CITY OF LOS ANGELES

INTER-DEPARTMENTAL CORRESPONDENCE

SUBJECT: BSS/BOE RE-EVALUATION - COUNCIL FILE 18-0707 CALIFORNIA ENVIRONMENTAL QUALITY ACT APPEAL OF A TREE REMOVAL PERMIT REQUEST UNDER THE SIDEWALK REPAIR PROGRAM FOR 1225-1254 NORTH CHEROKEE AVENUE

Alternative 1: Rerouting Pedestrians using the Roadway

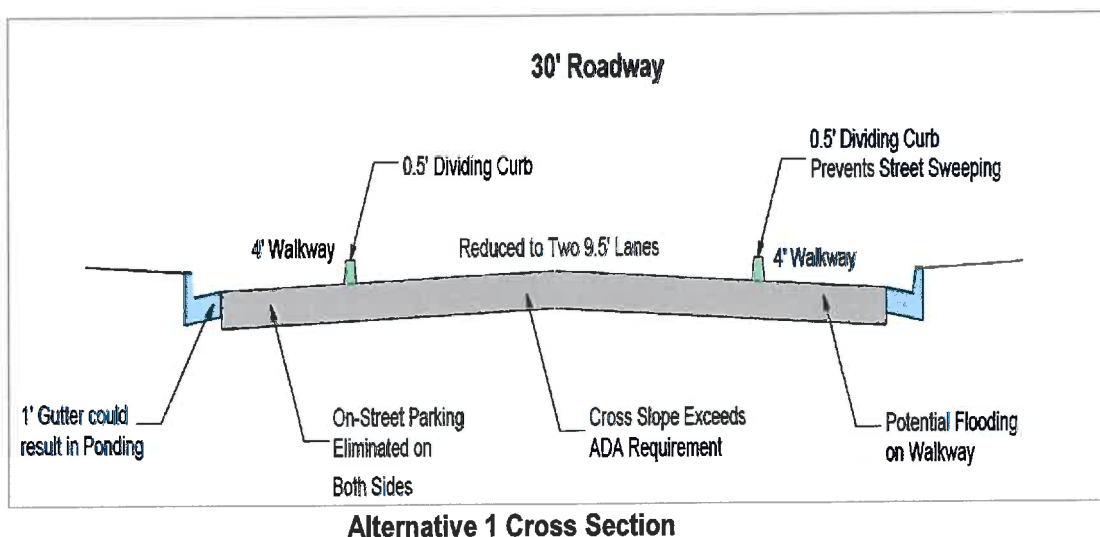
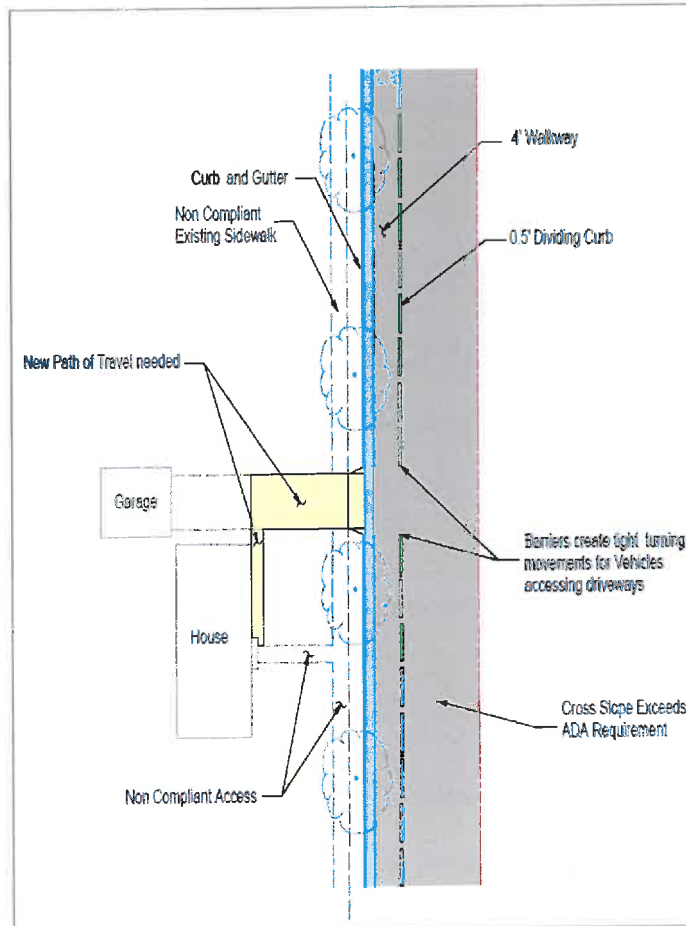
In this concept, the pedestrian path of travel has been rerouted from the existing sidewalk in the parkway to delineated walkway within the existing roadway section; the existing sidewalk would be removed. Pedestrian and vehicular traffic would be separated by the installation of a dividing curb for safety. The existing roadway section would be reconfigured to allow for two 9.5-foot traffic lanes and a 4-foot delineated walkway in each direction. All on street parking would be eliminated on both sides of Cherokee Ave for the entire length of the roadway. The following factors were considered for this alternative:

- The roadway cross slope exceeds ADA standards. The existing roadway cross slope in the area of the walkway varies from 0% to 8.4%, which exceeds the 2.0% maximum cross slope per ADA requirements. The entire roadway would require reconstruction / repaving to achieve the 2.0% cross slope.
- The already substandard roadway would be narrowed to 19-feet to accommodate two 9.5-foot lanes.
- On-Street parking would be eliminated on both sides.

- The proximity of pedestrians to the traffic lanes is a safety concern, especially with the narrowed lanes.
- The delineated walkway limits the drainage path which could result in potential flooding of the walkway. The one-foot gutter pan would have very limited carrying capacity for storm water runoff. Storm flows could exceed the gutter capacity and encroach in the pedestrian path of travel.
- The installation of the dividing curb would eliminate conventional street sweeping along the curb, further reducing gutter capacity, and increasing the flood risks.
- A new path of travel will be needed from the new walkway to each property; existing access between individual homes and the proposed delineated walkway would exceed the maximum ADA ramp grades of 8.33%.

Alternative 2: Removing Sidewalk and Constructing New Sidewalk in the Roadway

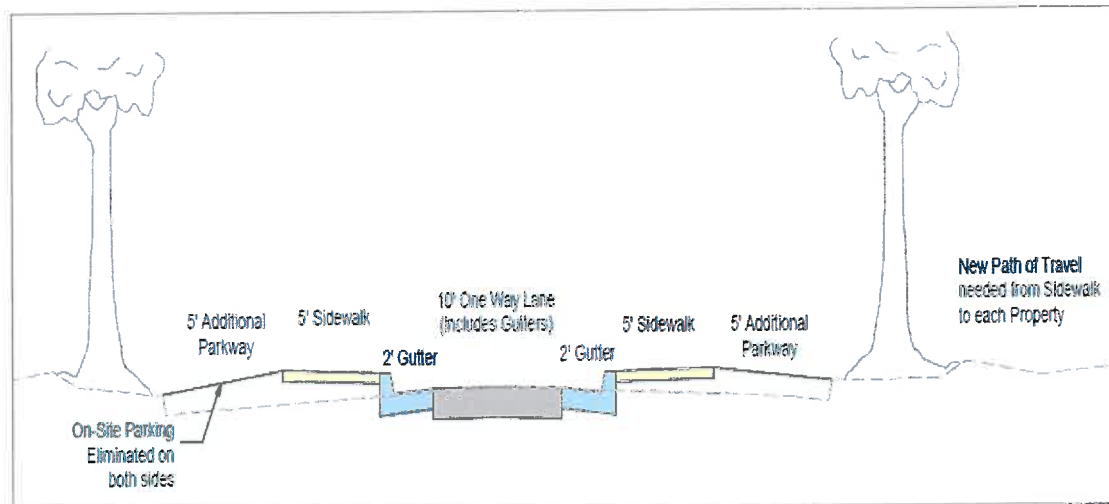
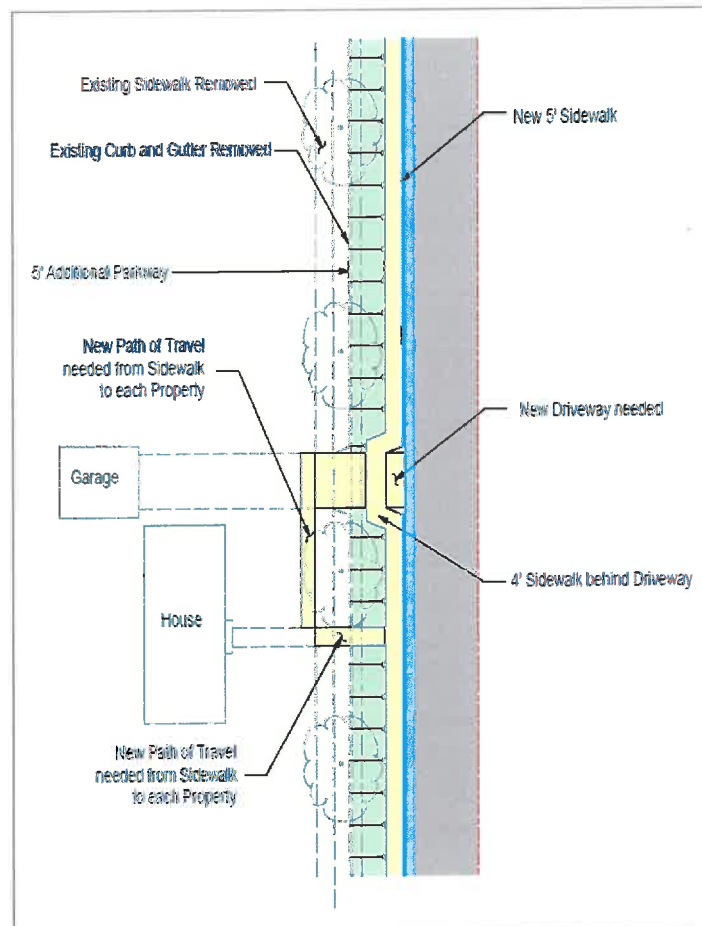
A new sidewalk is constructed adjacent to a narrowed roadway and the existing sidewalk has been removed in this concept. The existing roadway section would be reconfigured to allow for a 10-foot traffic lane in one direction, which includes two 2-foot gutters. Adjacent to the curb would be a new 5-foot sidewalk in each direction. All on street parking would be eliminated for the entire length of the roadway on both sides of Cherokee. The following were considered for this alternative:

- The already substandard roadway would be narrowed to 10-feet.
- Traffic and property access would be restricted to one direction.
- On-Street parking would be eliminated on both sides.
- A new path of travel will be needed from the new sidewalk to each property. Path of travel slopes between individual homes and the new sidewalk would exceed the maximum ADA ramp grades of 8.33%.

Alternative 3: Ramping / Meandering Sidewalk

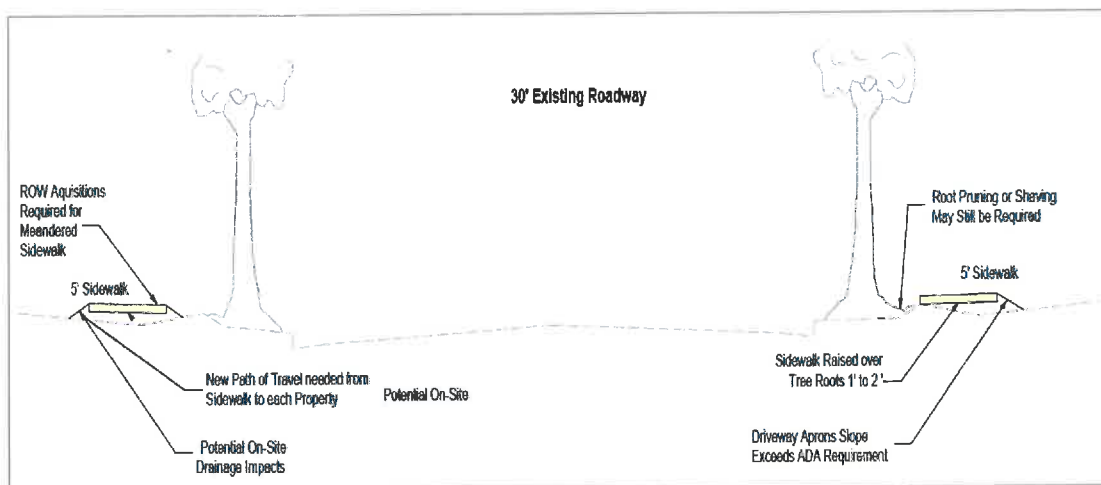
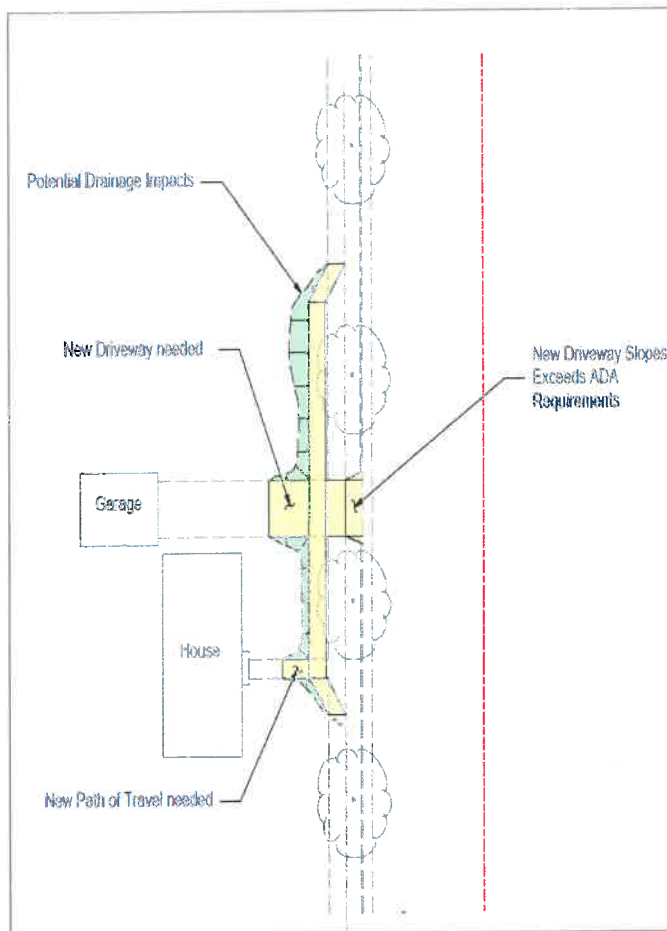
In this concept, the existing non-compliant sidewalk has been removed and a new sidewalk is raised or meandered to meet ADA requirements while avoiding the trees. The existing 30-foot roadway section would remain. The following were considered for this alternative:

- Significant ROW acquisitions would be required for meandering. The process for voluntary easement dedication is approximately 6 months. The property owner is responsible for submitting a payment of \$3,416.51. It is not known if property owners are willing to volunteer their property.
- Proposed sidewalk will be elevated by more than one foot above the existing curb line.
- Extensive onsite private property modifications would be required to connect the proposed elevated sidewalk to the entryways for properties.

- Onsite driveway reconstruction would be required for all properties. Driveway apron slopes are greater than City standards. Some driveway aprons will exceed the maximum 10% slope and even go as steep as 20.4%. This could result in vehicles bottoming out / scaping the driveway aprons.
- Potential drainage issues could result in flooding on properties.
- Root pruning or shaving would still be required.

Alternative 4 Site Plan

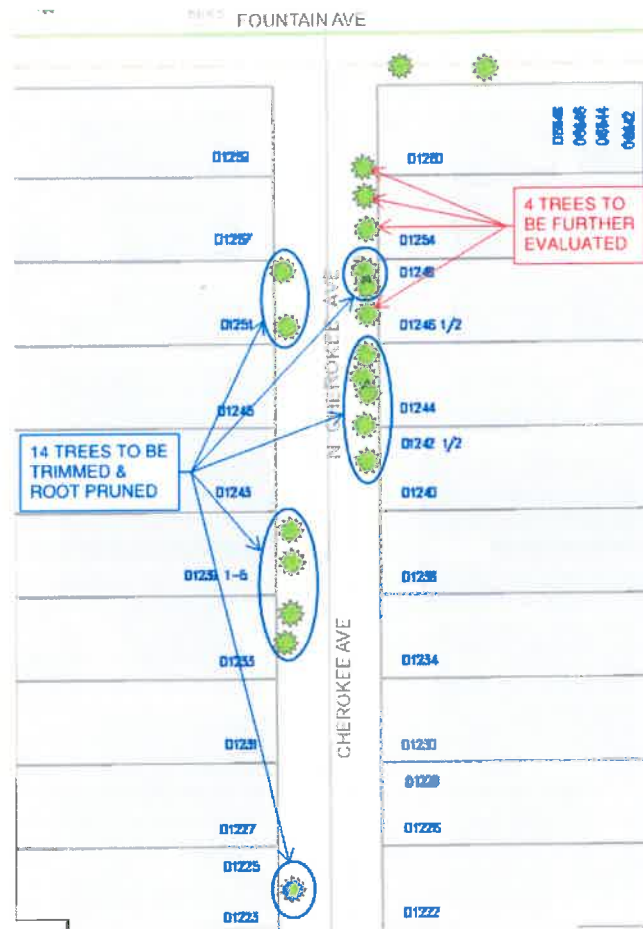
BSS (incl. BSS-UFD) and BOE revisited Cherokee Avenue on November 16, 2018 to re-evaluate the disposition of trees and explore options to save trees. UFD recommended substantial trimming to reduce the existing canopy, which could potentially prevent the removal of the trees. After a process of 8 to 12 months of tree stabilization and monitoring, UFD recommended proceeding with root pruning and sidewalk construction. Sidewalk widths would vary from 4-ft to 3-ft based on root evaluation during construction. This site would need to be monitored by UFD to ensure safety as the tree continues its growth. It is likely that trimming and pruning would be needed every 3 years to maintain the trees and prevent recurring sidewalk damage. UFD also noted that 4 trees in the vicinity of 1248 & 1254 Cherokee Avenue require further evaluation. Once the sidewalk is removed at those 4 tree

locations, UFD would be able to evaluate the root system and determine if these trees can be preserved as well.

After weighing all alternatives, potential fatal flaws, concerns, and benefits, the policy committee concluded that Alternative 4, the re-evaluation of tree disposition, is the recommended alternative for Cherokee Avenue. This option allows for ADA compliant sidewalk while preserving most and potentially all of the existing trees.
